# Access Audit Site Report

**Lake Bob Sandlin State Park**

**Accessibility Evaluation**

**Inspection Date: 04/06/2022**

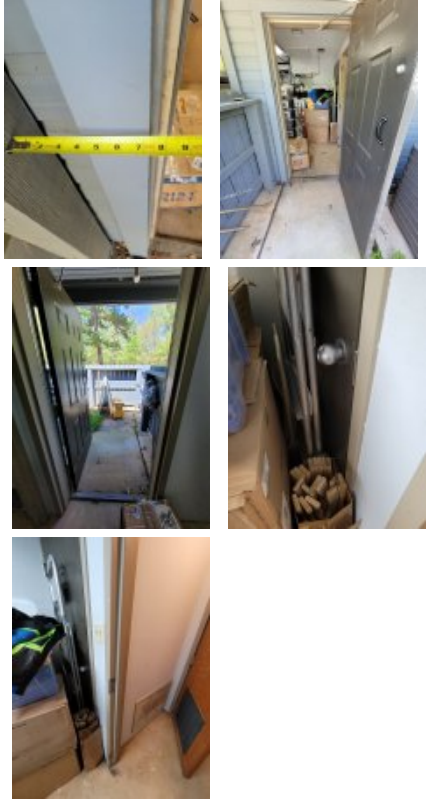
| Finding Number | Area Description                    | Lat/Long                  | Finding  | As Built   | Recommendation                      | Citation   | Photos  | Figure  |
|----------------|-------------------------------------|---------------------------|--|--|-------------------------------------|--|---|---|
| 21             | Headquarters Area: HQ Public Spaces | [33.0539542, -95.0991294] | The walkway contains abrupt vertical edges and/or variations over a 1/4 inch. 1/4 inch is the maximum vertical rise. Changes in level between 1/4 inch and 1/2 inch must be beveled at 1:2 or less. Changes in level greater than 1/2 inch must be by way of a ramp.     | .75" CIL at sign, .5" CIL at walk, 1.5" CIL at edge of walk/pavers (4 locations)   | Repair, bevel or ramp CIL along AR. | 2012 TAS Section: 303.2, 303.3<br><br>2010 ADAS Section: 303.2, 303.3                    |   |    |
| 22             | Headquarters Area: HQ Public Spaces | [33.0539542, -95.0991294] | There is a gap spaced greater than a 1/2 inch. Openings in floor or ground surfaces shall not allow passage of a sphere more than 1/2 inch diameter. Elongated openings shall be placed so that the long dimension is perpendicular to the dominant direction of travel. | 1.75" gap at exit parking, 2" gap near exit side parking, 1", 1.25", 1.5" gaps near front parking, .75" and 3" gaps in route near entry, 1.25" and 3" gaps at sign | Correct or fill gaps to be max .5". | 2015 ABAAS Section: 302.3<br><br>2012 TAS Section: 302.3<br><br>2010 ADAS Section: 302.3 |  |  |

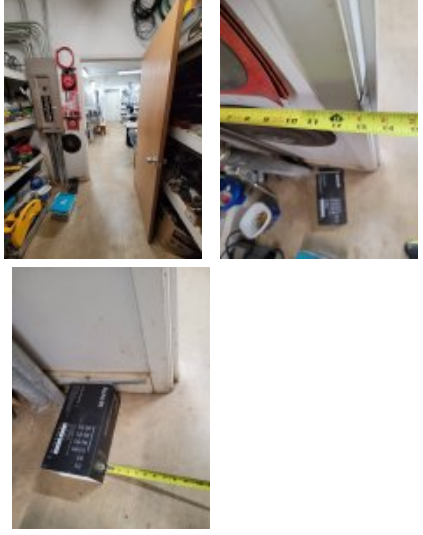
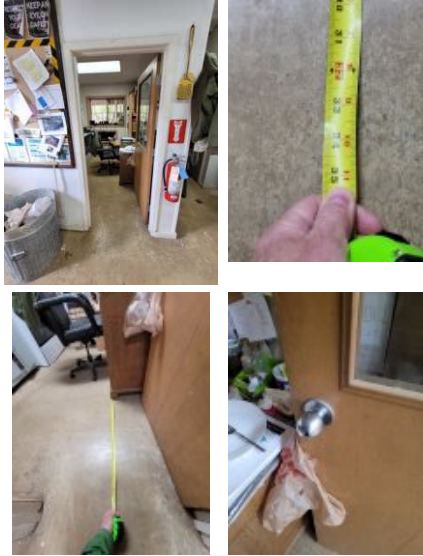
| Finding Number | Area Description            | Lat/Long                    | Finding   | As Built  | Recommendation  | Citation  | Photos  | Figure  |
|----------------|-----------------------------|-----------------------------|---|---|---|---|---|---|
| 41             | Employee Areas: Maintenance | [33.0599378 , -95.087584 4] | This restroom is not accessible. Where existing toilet rooms or bathing rooms do not comply, directional signs indicating the location of the nearest accessible toilet room or bathing room within the facility shall be provided. Signs shall include the International Symbol of Accessibility. Where existing toilet rooms or bathing rooms do comply), the accessible toilet rooms or bathing rooms shall be identified by the International Symbol of Where clustered single user toilet rooms or bathing facilities are permitted, accessible toilet rooms or bathing facilities shall be identified by the International Symbol of Accessibility unless all toilet rooms and bathing facilities are accessible. | Lacks directional signage                                 | Restroom not accessible, acquire and mount signage directing patrons to accessible restroom.  | 2015 ABAAS Section: F216.8<br>2012 TAS Section: 216.8<br>2010 ADAS Section: 216.8   |    |    |
| 42             | Employee Areas: Maintenance | [33.0599456 , -95.087612 6] | The restroom sign does not comply with one or more applicable requirements for the location, height, and properties of the sign.  | Lacks any signage   | Acquire and mount signage, including Braille, raised lettering and access symbol mounted on wall, latch side of door, 48" to baseline of lowest character and 60" to baseline of highest character. | 2015 ABAAS Section: F216.2, 703.1, 703.2, 703.5, 703.6<br>2012 TAS Section: 216.2, 703.1, 703.2, 703.5, 703.6<br>2010 ADAS Section: 216.2, 703.1, 703.2, 703.5, 703.6 |    |    |
| 43             | Employee Areas: Maintenance | [33.0599434 , -95.087585 7] | The route of travel at this location does not provide a minimum width of 36 inches. The clear width shall be permitted to be reduced to 32 inches minimum for a length of 24 inches maximum provided that reduced width segments are separated by segments that are 48 inches long minimum and 36 inches wide minimum.  | 24" width to restroom in maintenance due to hanging coats | Widen AR to compliant 36" clear width.  | 2015 ABAAS Section: 403.5.1<br>2012 TAS Section: 403.5.1<br>2010 ADAS Section: 403.5.1  |  |  |

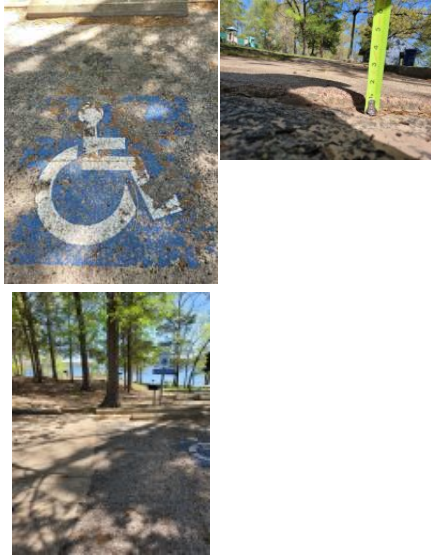
| Finding Number | Area Description           | Lat/Long                   | Finding   | As Built                                  | Recommendation   | Citation   | Photos   | Figure  |
|----------------|----------------------------|----------------------------|---|---|--|--|--|---|
| 70             | Trailhead: Trail Restrooms | [33.061146, -95.091786 1]  | Minimum maneuvering clearances at doors and gates shall comply with 404.2.4. Maneuvering clearances shall extend the full width of the doorway and the required latch side or hinge side clearance. Maneuvering clearances shall have a max slope of 2.08%. The threshold has a vertical change greater than 1/4 inch high. The threshold at a doorway shall be no higher than 1/2 inch. Changes in level between 1/4 inch and 1/2 inch must be beveled at 1:2 or less. 1/4 inch is the maximum vertical rise.  | 2" CIL at threshold, 4 risers for 29" AFF | For all doors along the public circulation route, provide required maneuvering clearance on push and pull side of doors. For all doors along the public circulation route, repair, bevel, or ramp CILs at door entries to max .25". For all doors along the public circulation route, provide beveled threshold. For all doors along the public circulation route, provide ramp or other accessible route instead of or in addition to stairs. | 2010 ADAS Section: 404.2.3, 404.2.7, 404.2.4, 404.2.11, 404.2.11 Exception             |   |   |
| 71             | Trailhead: Trail Restrooms | [33.0609842, -95.091786 1] | The door opening does not provide at least 32 inches between the face of the door and the opposite stop. Door openings shall provide a clear width of 32 inches minimum. Clear openings of doorways with swinging doors shall be measured between the face of the door and the stop, with the door open 90 degrees. There shall be no projections into the required clear opening width lower than 34 inches above the finish floor or ground. Projections into the clear opening width between 34 inches and 80 inches above the finish floor or ground shall not exceed 4 inches. | 28.5" width                               | Replace door with one having 32" clear width.  | 2015 ABAAS Section: 404.2.3<br>2012 TAS Section: 404.2.3<br>2010 ADAS Section: 404.2.3 |  |  <p>Hinged Door or Gate</p> |

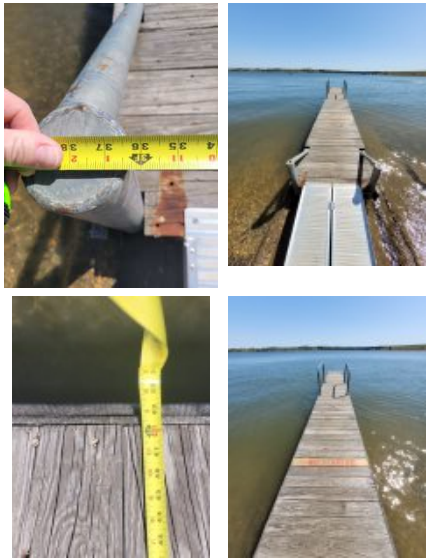
| Finding Number | Area Description                         | Lat/Long                             | Finding   | As Built  | Recommendation  | Citation   | Photos   | Figure   |
|----------------|--|--------------------------------------|---|---|---|--|--|--|
| 81             | Day Use Area:<br>Day Use - Fish Cleaning | [33.0484926<br>,<br>-95.095163]      | There is insufficient turning space within this room or space. The space required for a wheelchair to make a 180-degree turn is a clear space of 60 inches in diameter or a T-shaped space.   | Lacks T or turning area, has 36" around perimeter | Provide min 60" by 60" turning space at fish cleaning station | 2015 ABAAS<br>Section:<br>304.3.1,<br>304.3.2<br><br>2012 TAS<br>Section:<br>304.3.1,<br>304.3.2<br><br>2010 ADAS<br>Section:<br>304.3.1,<br>304.3.2 |   |   |
| 82             | Day Use Area:<br>Day Use - Fish Cleaning | [33.0484915<br>,<br>-95.095168<br>3] | The accessible route contains running slopes greater than 5 percent and cross slopes greater than 2 percent across the width of the walk and has not been constructed as a ramp (i.e. handrails, wheel guides, etc.). When the slope in the direction of travel of any walk exceeds 1 unit vertical in 20 units horizontal (5-percent slope), it must be constructed as ramp. Surface cross slopes must not exceed one unit vertical in 48 units. Horizontal (2-percent slope). | 2.4% cross slope                                  | Correct or repair slope to max 5% running and 2.08% cross.    | 2015 ABAAS<br>Section:<br>403.3<br><br>2012 TAS<br>Section:<br>403.3<br><br>2010 ADAS<br>Section:<br>403.3   |  |  |

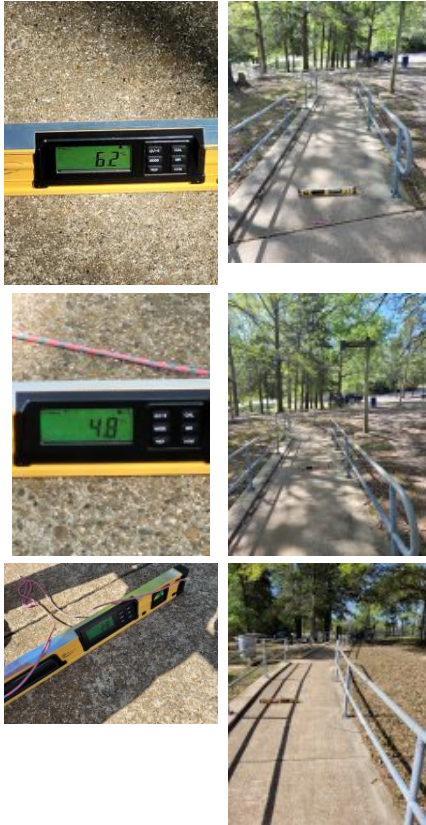
| Finding Number | Area Description                         | Lat/Long             | Finding   | As Built  | Recommendation   | Citation   | Photos  | Figure  |
|----------------|--|----------------------|---|---|--|--|---|---|
| 86             | Day Use Area:<br>Day Use - Fish Cleaning | [33.0485, -95.09515] | The accessible route of travel contains cross slopes greater than 2%. Cross slopes shall not exceed one unit vertical in 48 units horizontal (2-percent slope).   | 3.7% slope end of, 5.2% slope middle of, 7.2% slope beginning of route - approximately 40' of slope | Correct or repair cross slope along AR to max 2.08%.   | 2015 ABAAS Section: 403.3<br><br>2012 TAS Section: 403.3<br><br>2010 ADAS Section: 403.3 |   |    |
| 87             | Day Use Area:<br>Day Use - Fish Cleaning | [33.0485, -95.09515] | The transition from the curb ramp to the walk, gutter or street is not flush and free of abrupt changes in level. Transitions from ramps to walks, gutters or streets shall be flush and free of abrupt change. Maximum slopes of adjoining gutters, road surface immediately adjacent to the curb ramp, or accessible route shall not exceed one unit vertical in 20 units horizontal (5-percent slope). | Lacks curb ramp   | Create a curb ramp to be max running slope 8.33%, max cross slope 2.08%, having a top landing as wide as the ramp and 36" deep and side flares with a max slope 10%. | 2015 ABAAS Section: 406.2<br><br>2012 TAS Section: 406.2<br><br>2010 ADAS Section: 406.2 |  |  |

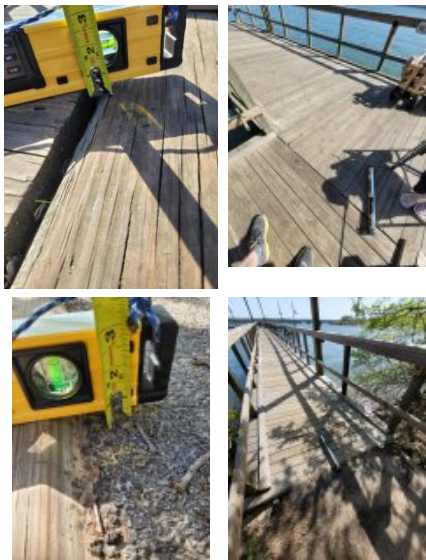
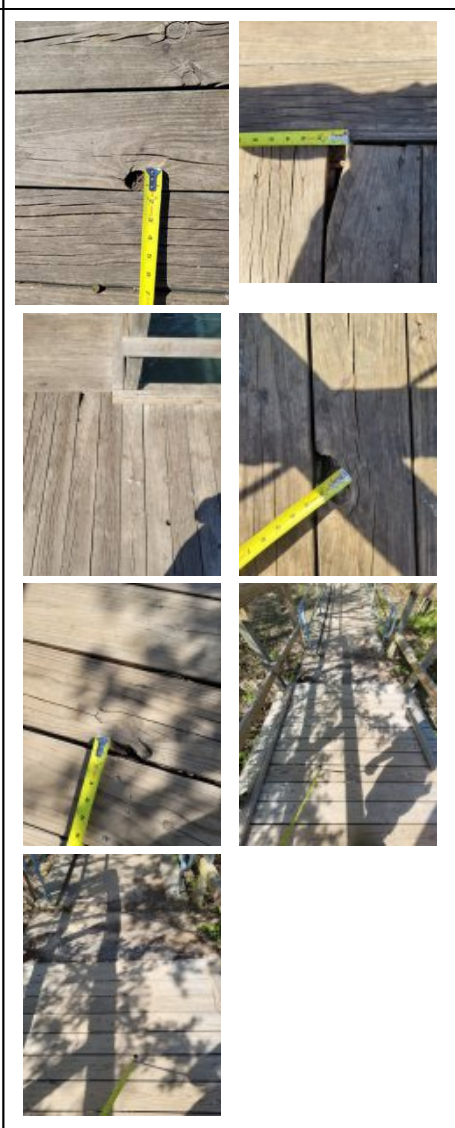
| Finding Number | Area Description                   | Lat/Long                       | Finding  | As Built   | Recommendation  | Citation  | Photos   | Figure  |
|----------------|------------------------------------|--------------------------------|--|--|---|---|--|---|
| 98             | Day Use Area:<br>Day Use - Fishing | [33.04817,<br>-95.093939<br>9] | The handrail is not continuous the entire length of the ramp. The handrail must be continuous. Handrails shall be placed on each side of each ramp, shall be continuous the full length of the ramp. The inside handrail on switch back or dogleg ramps shall always be continuous. Handrail shall have top and bottom extensions. | long ramp from restroom to pier- 0 of 6 sets extend at top or bottom | Replace handrail with one that is continuous along the full length of the ramp and having required top and bottom extensions. | 2015 ABAAS<br>Section:<br>505.3,<br>505.10.1<br><br>2012 TAS<br>Section:<br>505.3,<br>505.10.1<br><br>2010 ADAS<br>Section:<br>505.3,<br>505.10.1 |  |  |

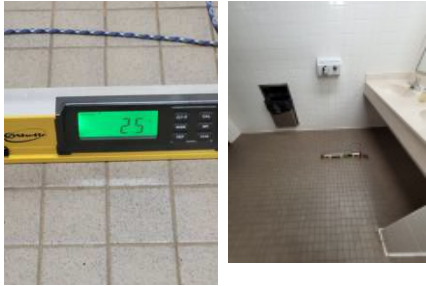
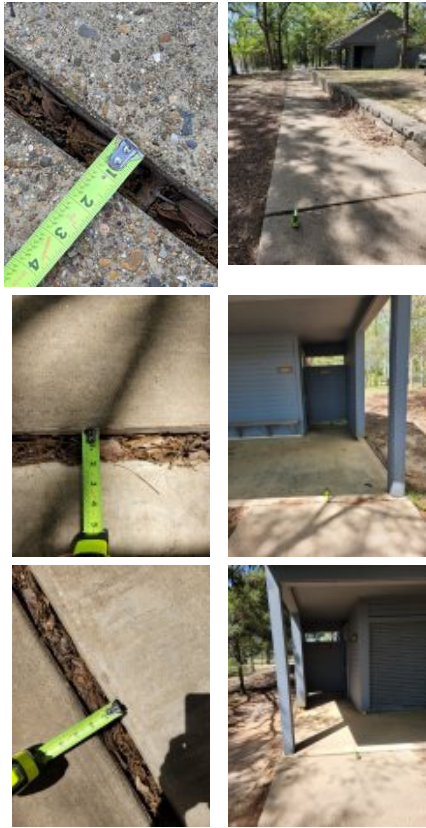
| Finding Number | Area Description                          | Lat/Long                             | Finding  | As Built                       | Recommendation   | Citation  | Photos   | Figure  |
|----------------|---|--------------------------------------|--|--------------------------------|--|---|--|---|
| 116            | Day Use Area:<br>Day Use - Men's Restroom | [33.0482168<br>,<br>-95.093857<br>5] | The bench is not deep enough or long enough or is missing. Benches shall be provided having seats that are 42 inches long minimum and 20 inches deep minimum and 24 inches deep maximum. The bench shall provide for back support or shall be affixed to a wall. Back support shall be 42 inches (1065 mm) long minimum and shall extend from a point 2 inches (51 mm) maximum above the seat surface to a point 18 inches (455 mm) minimum above the seat surface. Back support shall be 2½ inches (64 mm) maximum from the rear edge of the seat measured horizontally. The top of the bench seat surface shall be 17 inches (430 mm) minimum and 19 inches (485 mm) maximum above the finish floor or ground. Clear floor or ground space complying with 305 shall be provided and shall be positioned at the end of the bench seat and parallel to the short axis of the bench | bench lacks CFS, not compliant | Replace bench in dressing area with one having a seat depth of 20" to 24" deep, 42" long, affixed to the wall or having a back and mounted 17" to 19" AFF and provide required clear floor space on the short axis of the bench.                                   | 2012 TAS<br>Section:<br>903.4, 903.2,<br>903.3, 903.5<br><br>2010 ADAS<br>Section:<br>903.4, 903.2,<br>903.3, 903.5   |   |  |
| 117            | Day Use Area:<br>Day Use - Men's Restroom | [33.0482157<br>,<br>-95.093853<br>3] | The restroom sign does not comply with one or more applicable requirements for the location, height, and properties of the sign.   | Lacks compliant signage        | Replace sign with one of contrasting colors that includes Braille, raised characters, and the symbol of accessibility and mount on the wall, latch side of the door, 48" to the baseline of the lowest character and 60" to the baseline of the highest character. | 2015 ABAAS<br>Section:<br>F216.2,<br>703.1, 703.2,<br>703.5, 703.6<br><br>2012 TAS<br>Section:<br>216.2, 703.1,<br>703.2, 703.5,<br>703.6<br><br>2010 ADAS<br>Section:<br>216.2, 703.1,<br>703.2, 703.5,<br>703.6 |  |  |

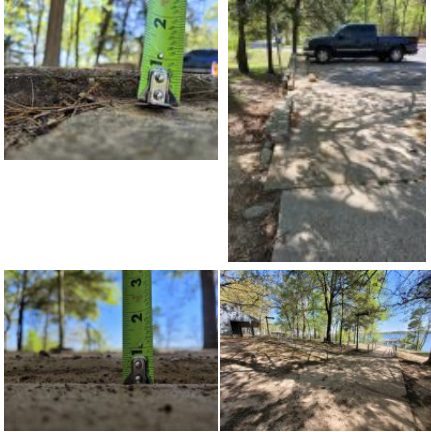
| Finding Number | Area Description                                  | Lat/Long                             | Finding   | As Built                                 | Recommendation   | Citation   | Photos | Figure |
|----------------|---|--------------------------------------|---|--|--|--|--------|--------|
| 137            | Day Use Area:<br>Day Use -<br>Women's<br>Restroom | [33.0482262<br>,<br>-95.093856<br>7] | The toilet is not located within the range to the side wall or partition. The centerline of the toilet shall be 17 inches minimum and 19 inches maximum side wall or partition in the ambulatory accessible toilet compartment. | 22" from tiled wall,<br>20" to partition | Remount toilet to 17" to 19" from the side wall to center line in ambulatory stalls. | 2015 ABAAS<br>Section:<br>604.9.1<br><br>2012 TAS<br>Section:<br>604.9.1<br><br>2010 ADAS<br>Section:<br>604.9.1   |        |        |
| 138            | Day Use Area:<br>Day Use -<br>Women's<br>Restroom | [33.0482217<br>,<br>-95.093864<br>8] | The stall door fails to comply with all of the door requirements. The stall door must be a minimum of 32" wide and have compliant hardware on both sides. The stall door must be self-closing.                                  | Lacks self-closing door                  | Adjust stall door to be self-closing.  | 2015 ABAAS<br>Section:<br>404.2.3,<br>404.2.7,<br>604.8.2.2<br><br>2012 TAS<br>Section:<br>404.2.3,<br>404.2.7,<br>604.8.2.2<br><br>2010 ADAS<br>Section:<br>404.2.3,<br>404.2.7,<br>604.8.2.2 |        |        |

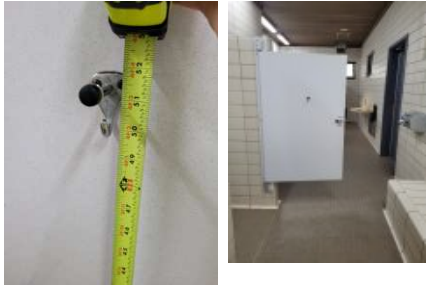
| Finding Number | Area Description  | Lat/Long                  | Finding  | As Built   | Recommendation  | Citation  | Photos   | Figure  |
|----------------|---|---------------------------|--|--|---|---|--|---|
| 188            | Fort Sherman/Cherokee Trace (FS/CT) Camping Areas: FS/CT - Men's Restroom | [33.0542963, -95.0880766] | The grab bar height and/or spacing fails. Grab bars must be mounted between 33" and 36" to the top of the gripping surface. There must be 1.5" of clearance between the grab bar and the wall. There must be a minimum of 1.5" of clearance below and minimum 12" above the grab bar to any dispenser or other obstruction.  | 1 bar at 36.5" AFF, 1 bar at 36.75" AFF, 5" between TP and bar | Remount grab bars in accessible stall to 33" to 36" above the finished floor (AFF). Remount toilet paper dispenser max 7" to 9" from front of toilet, 15" to 48" above the finished floor (AFF) and min 12" above or 1.5" below grab bar. | 2015 ABAAS Section: 609.3, 609.4<br><br>2012 TAS Section: 609.4, 609.3<br><br>2010 ADAS Section: 609.3, 609.4 |   |   |
| 189            | Fort Sherman/Cherokee Trace (FS/CT) Camping Areas: FS/CT - Men's Restroom | [33.0542941, -95.0880739] | The toilet paper is not installed within the compliant range in front of the toilet. Toilet paper dispensers shall be 7 inches minimum and 9 inches maximum in front of the water closet measured to the centerline of the dispenser. The outlet of the dispenser shall be 15 inches minimum and 48 inches maximum above the finish floor and shall not be located behind grab bars. Dispensers shall not be of a type that controls delivery or that does not allow continuous paper flow. There shall be a clearance of 1 1/2 inches minimum below the grab bar. | 4" to centerline of TP   | Remount toilet paper dispenser max 7" to 9" from front of toilet, 15" to 48" AFF and min 12" above or 1.5" below grab bar.  | 2015 ABAAS Section: 604.7<br><br>2012 TAS Section: 604.7<br><br>2010 ADAS Section: 604.7                      |  |  |
